SERVICE SLANTS

ISSUED BY WURLITZER SERVICE DEPT., NORTH TONAWANDA, N. Y.

SUBJECT: KIT 147 REMOTE VOLUME CONTROL UNIT MODIFICATION For Use With
Monophonic Phonograph Models 2500, 2510 and 2504

FIGURE 2

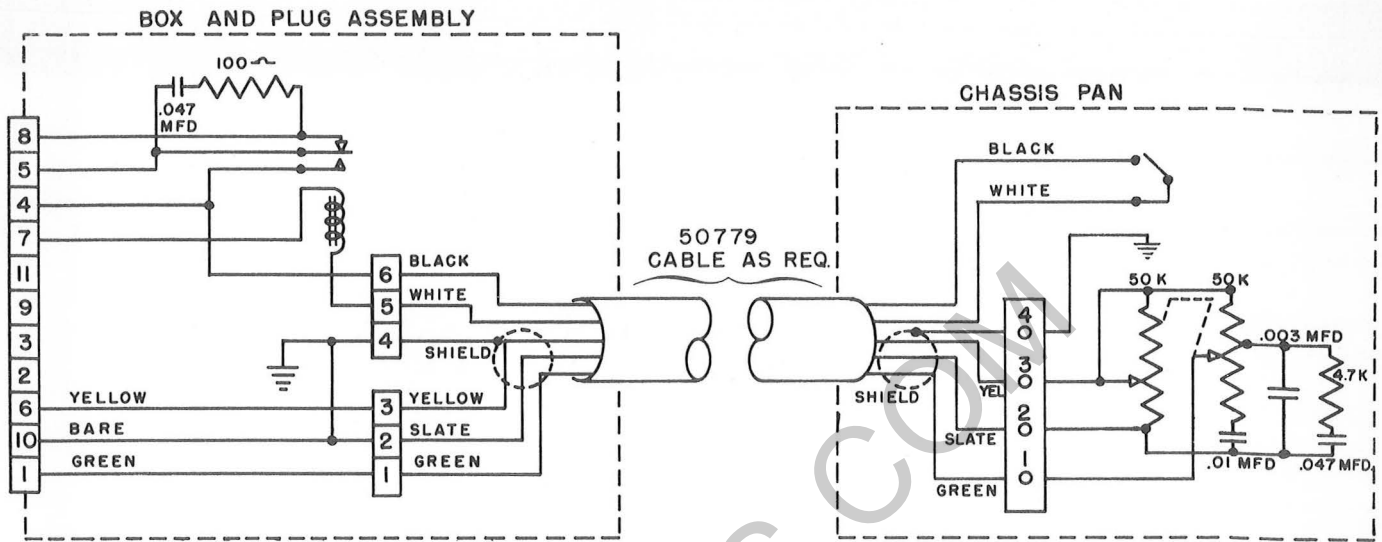
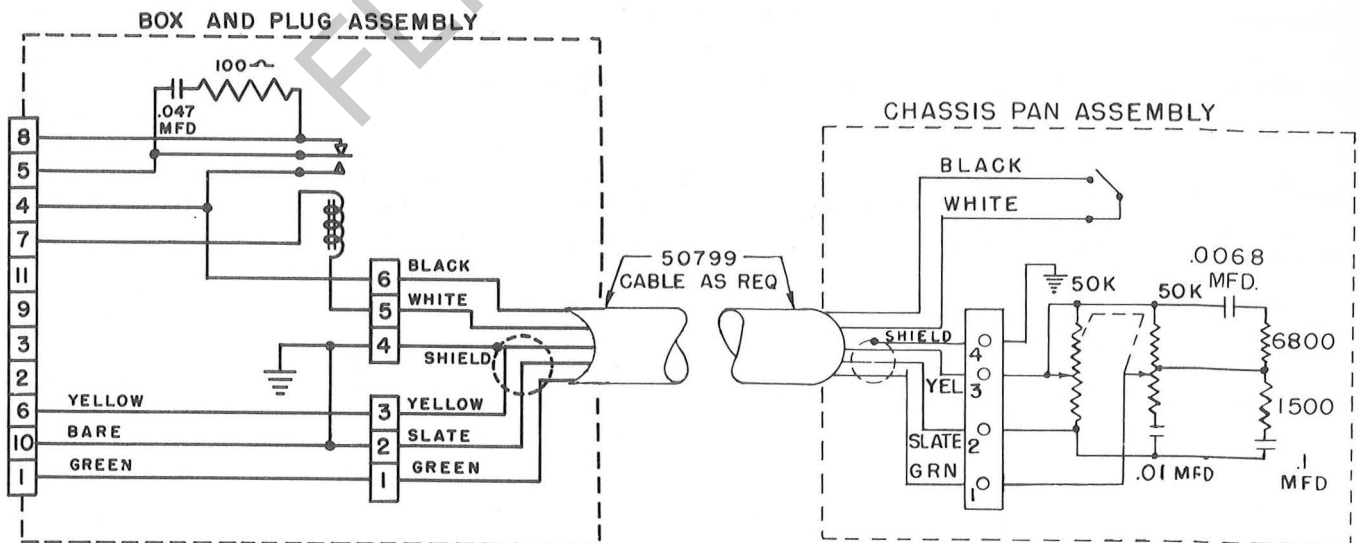
The following instructions are provided to enable the use of the major components of Kit 147 (now in a location) for a modified remote control unit that will operate properly on the above subject phonograph models.

It will be necessary to secure and replace certain resistors and condensers that are required for proper tone compensation. The electrical values of the resistors and condensers needed are shown in Figure 2. These parts may be obtained locally or purchased from our Parts Department.

Figure 1 represents the wiring of Kit 147 before modification. Figure 2 represents wiring of the modified Kit 147.

There are no changes necessary in the wiring of the relay box and plug assembly.

When ordering a new remote volume control unit from the factory to be used for the Model 2500 Series Monophonic Phonographs, it should be ordered as Kit 147A. This new kit is similar to the modified Kit 147.
